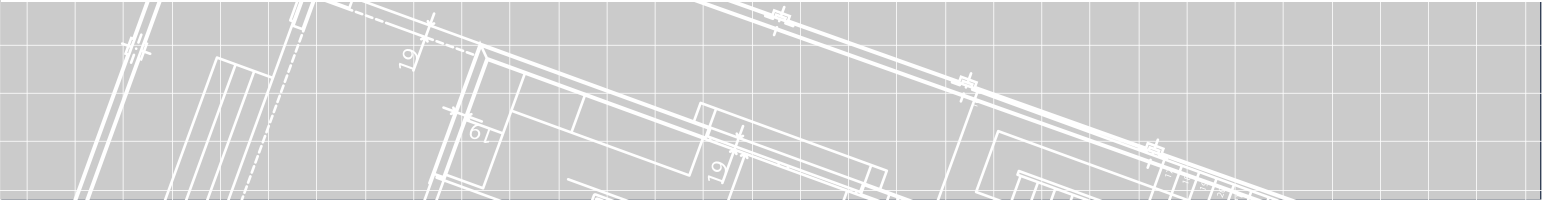
Matte Clear - 3XX-101 - applique (do you think the adhesion will show through? -- if so, let me know).  
Reverse engrave the design.

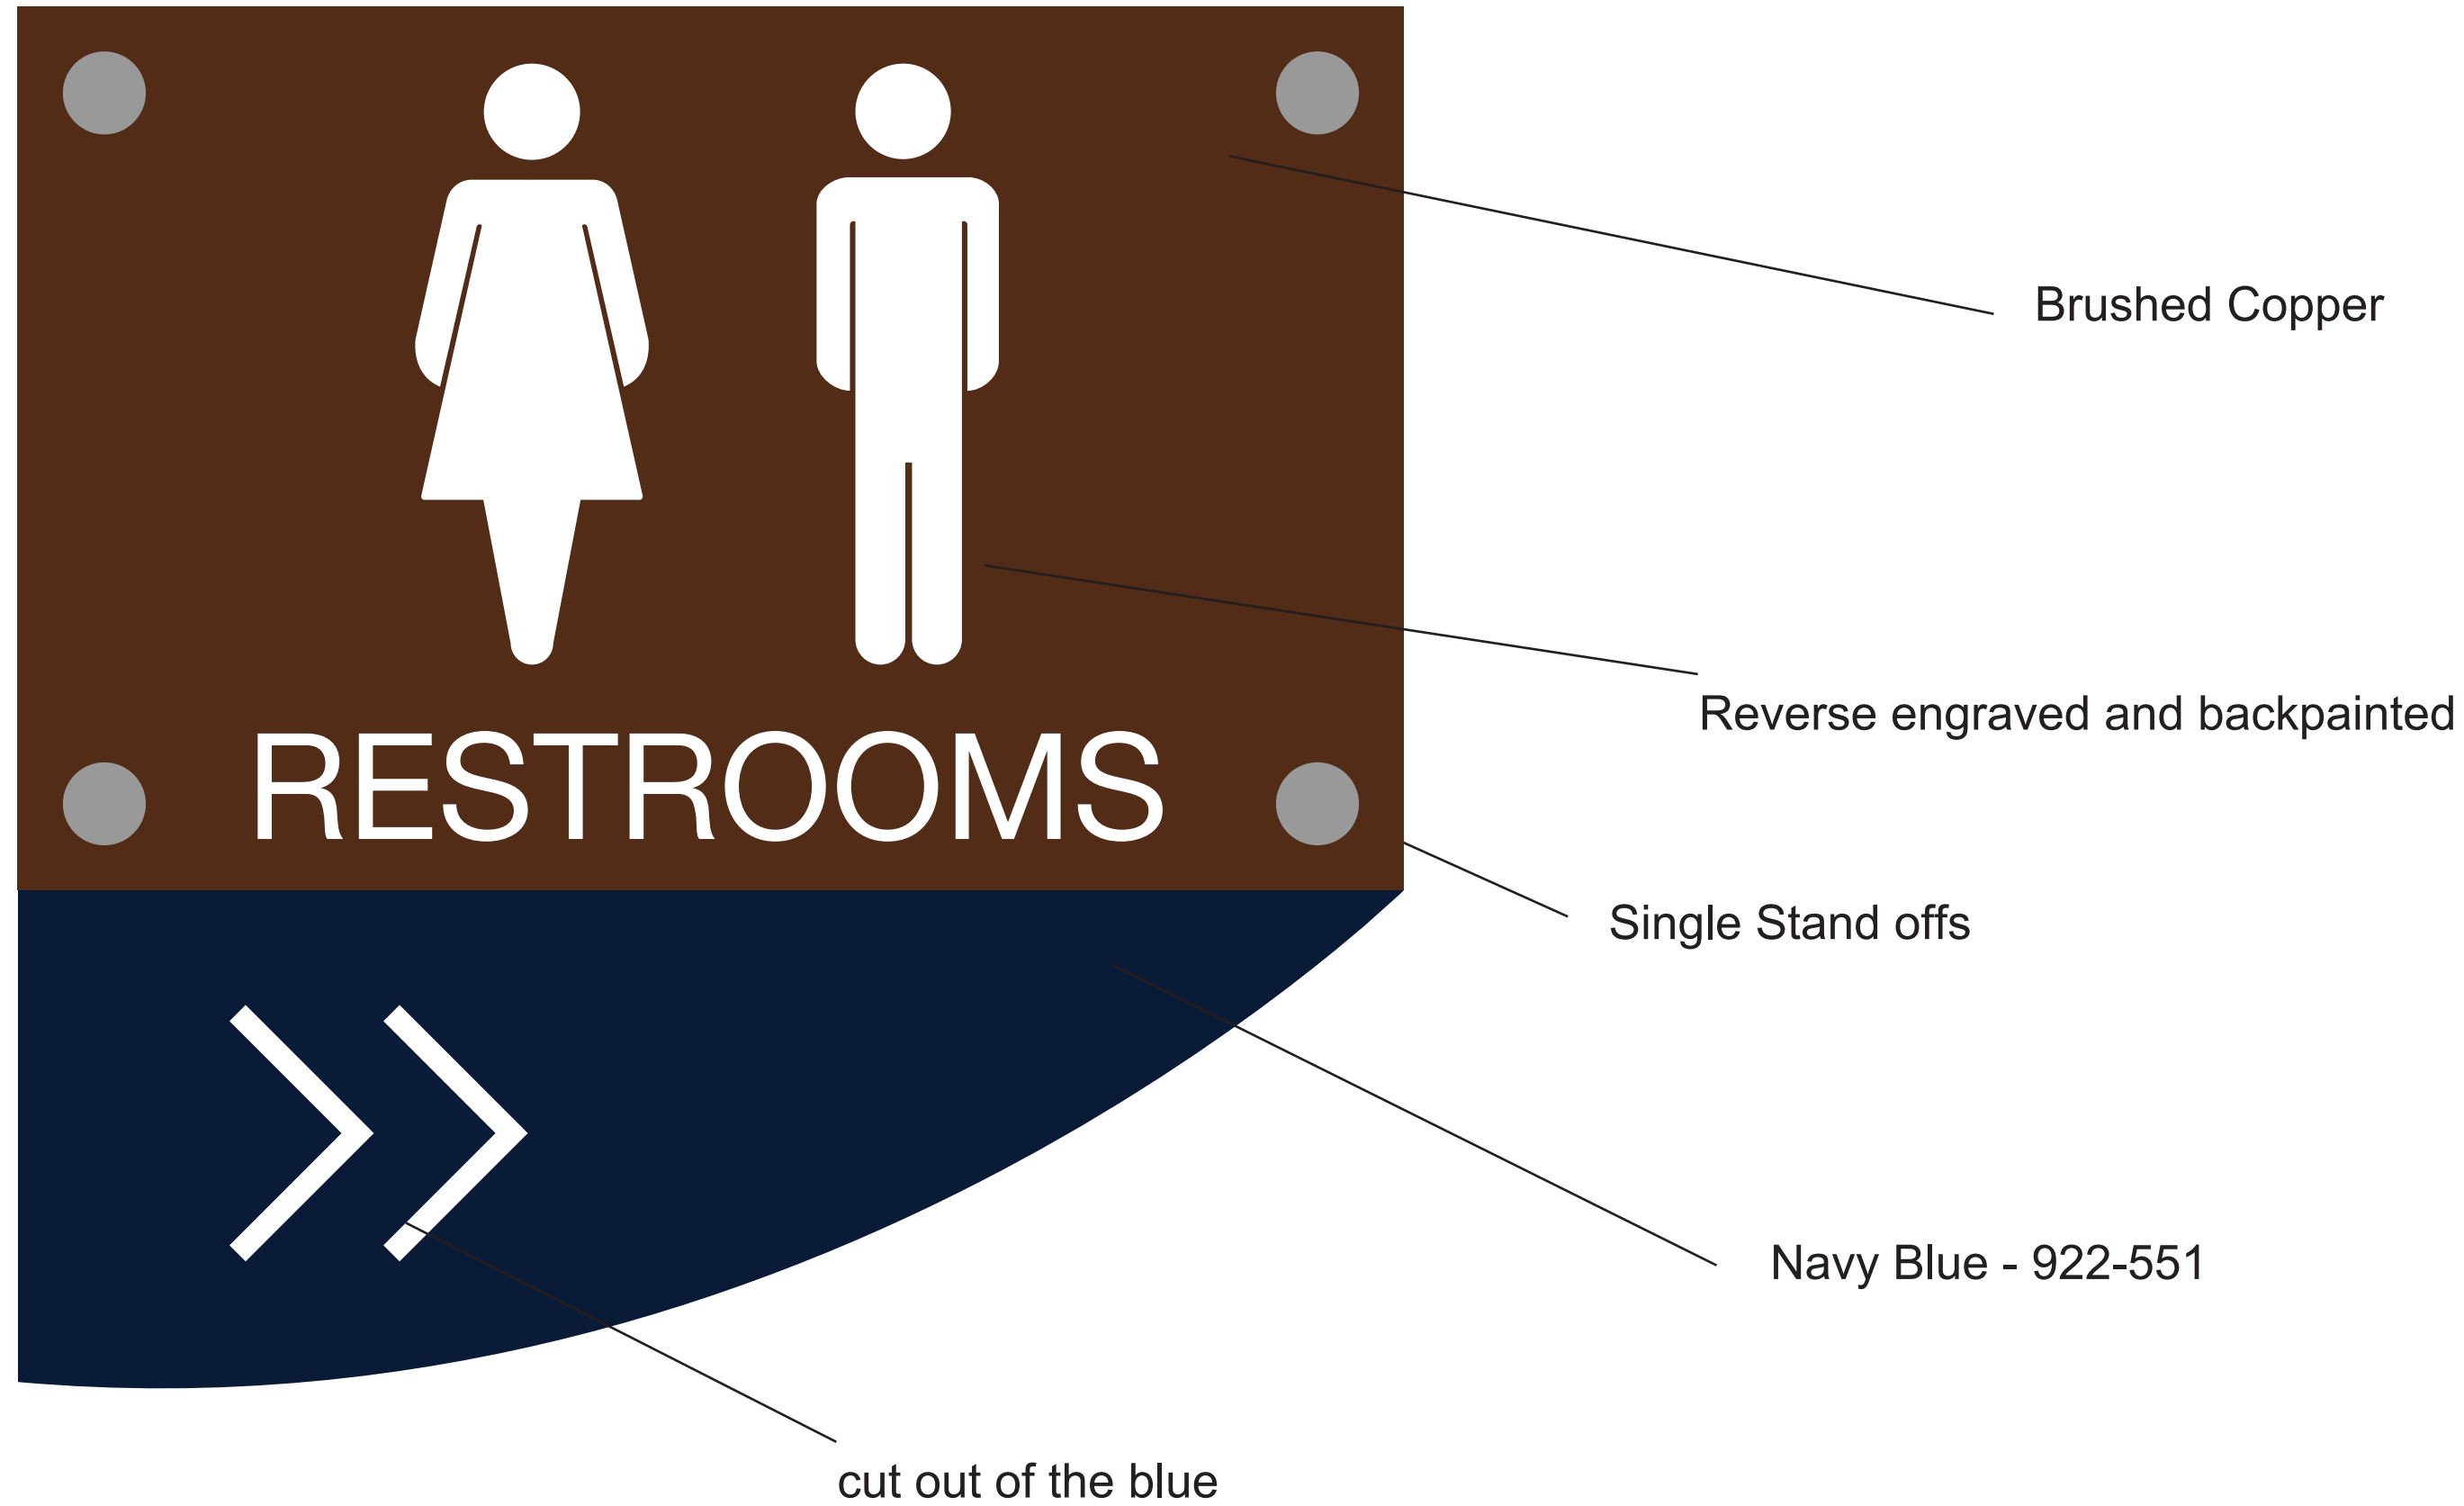
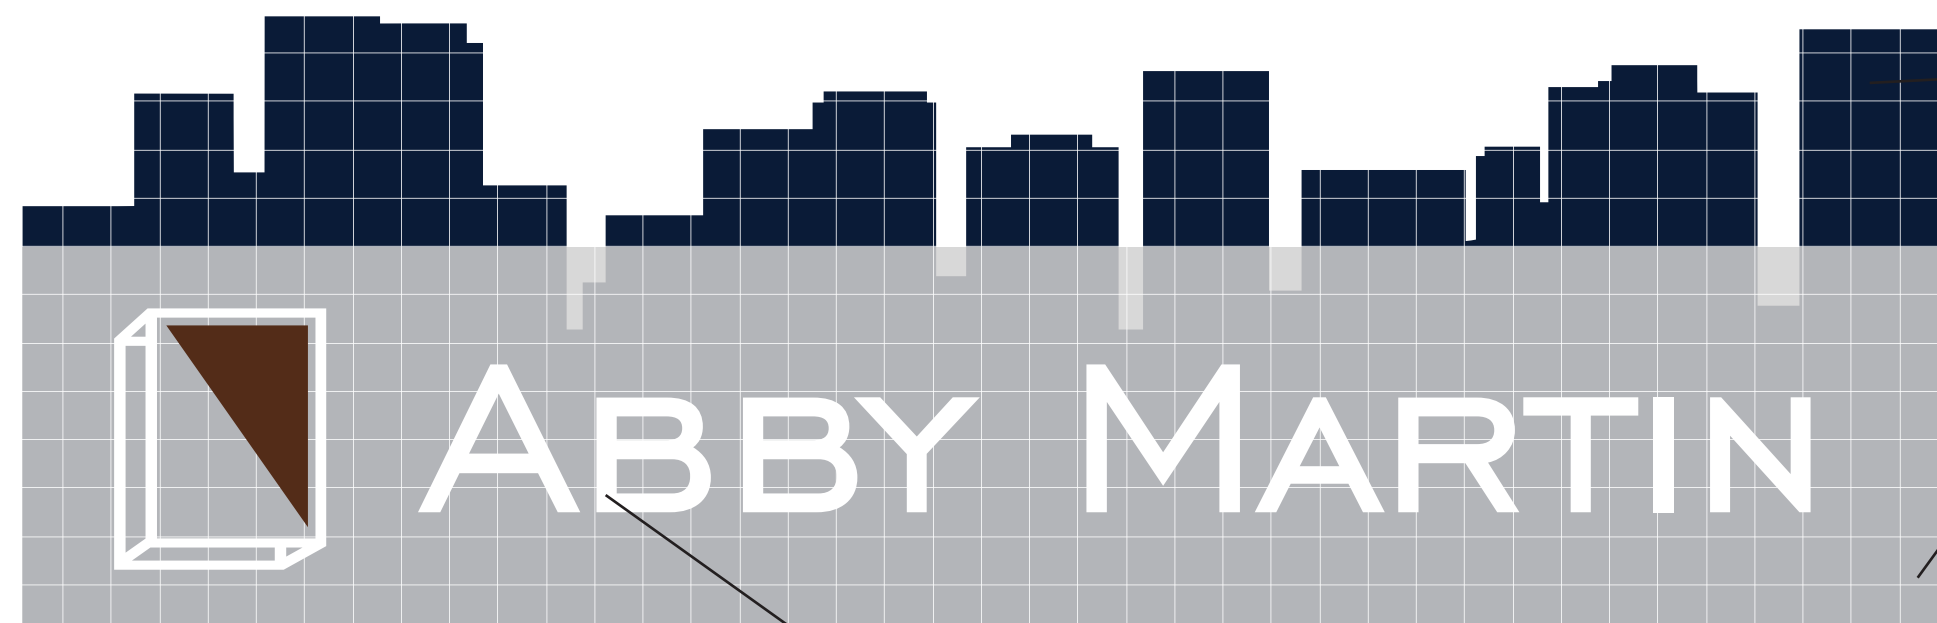
Clear - 3XX-101 - Applique (do you think the adhesion will show through? -- if so, let me know).  
Reverse engrave grid design.

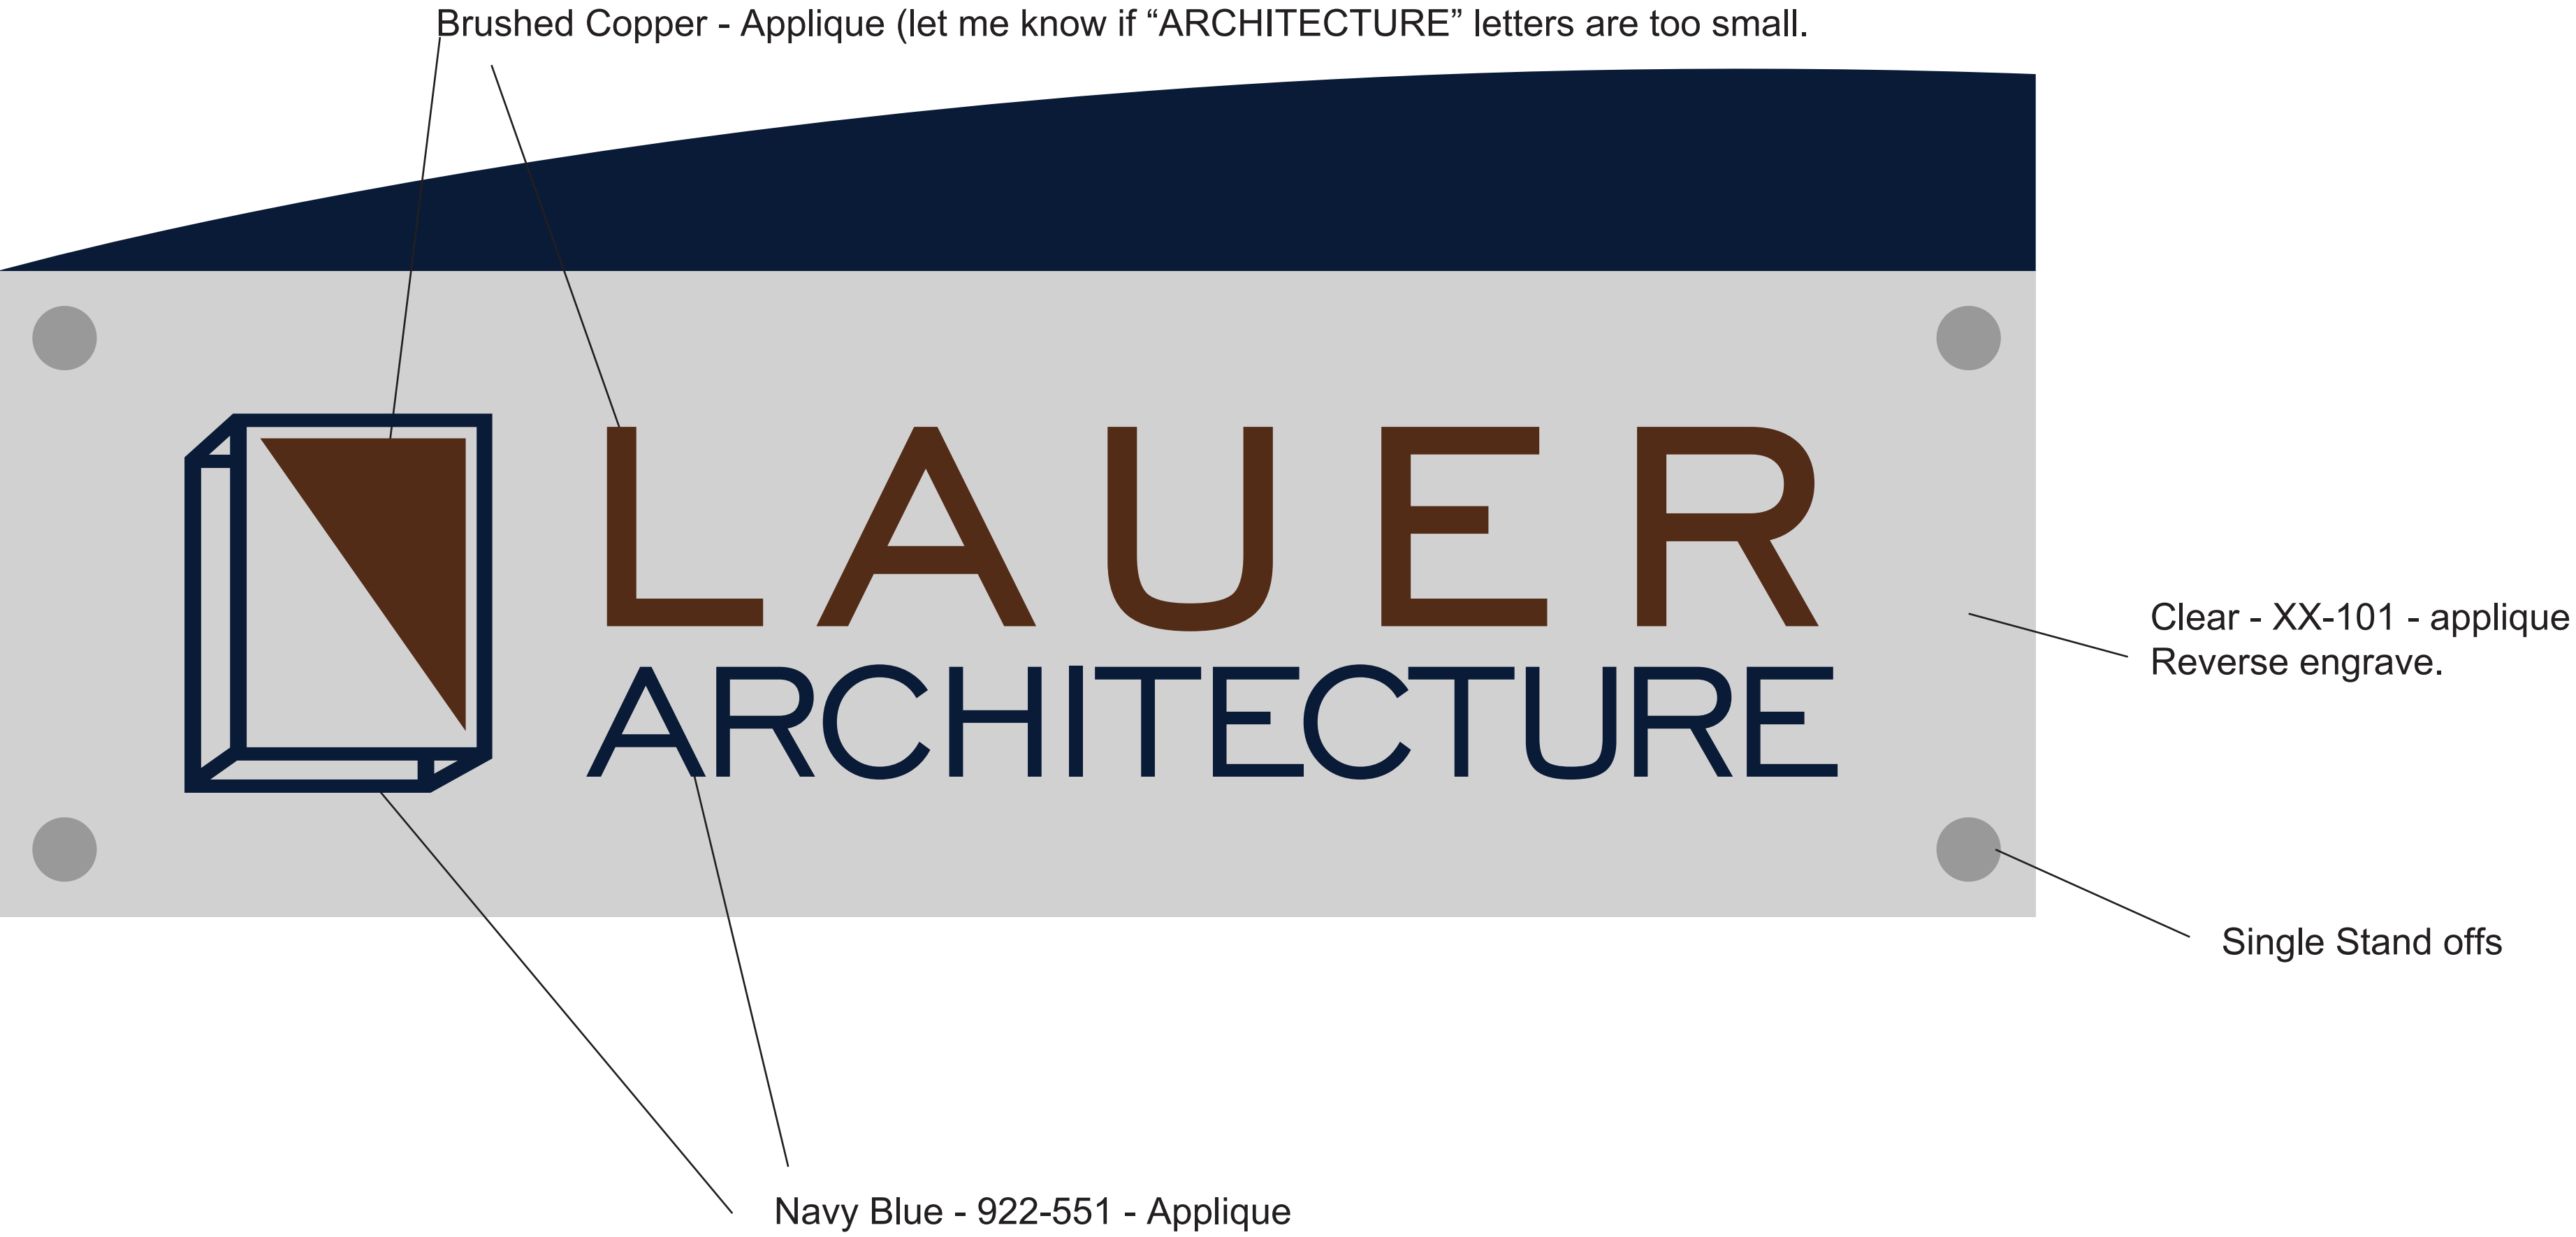
Brushed Copper - Applique (let me know if "ARCHITECTURE" letters are too small.)
